#### Working Party on the Transport of Perishable Foodstuffs

##### Proposals of amendments to the ATP

### Marking of multi-temperature equipment

#### Transmitted by the Government of the France

Example of marking

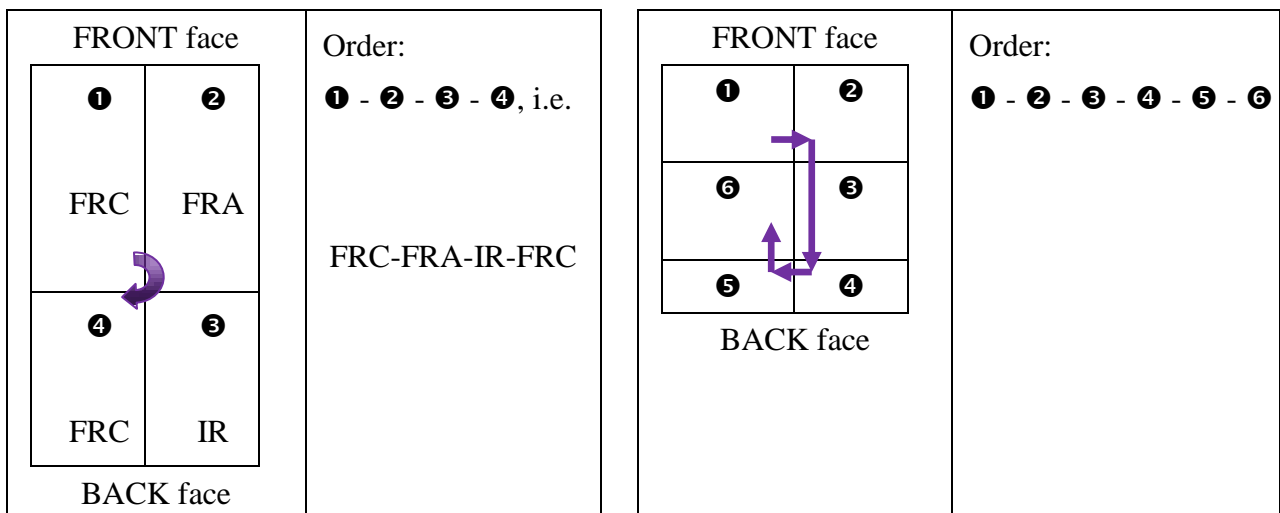
5. It is proposed that each compartment should be marked in line with the rules for marking mono-temperature equipment.
6. For equipment with three compartments, for example, the marking would be FRC-FRC-FRC if the performance of the three compartments is identical. If the performance is not identical, the compartments will have different markings, for example FRC-FRA, or RRC-IR.

**In the case of multi-compartment, multi-temperature equipment, each compartment is classified as a mono-temperature unit. The classification marks that appear on the distinguishing marks are ordered starting with the front left compartment or compartments and rotating clockwise.**
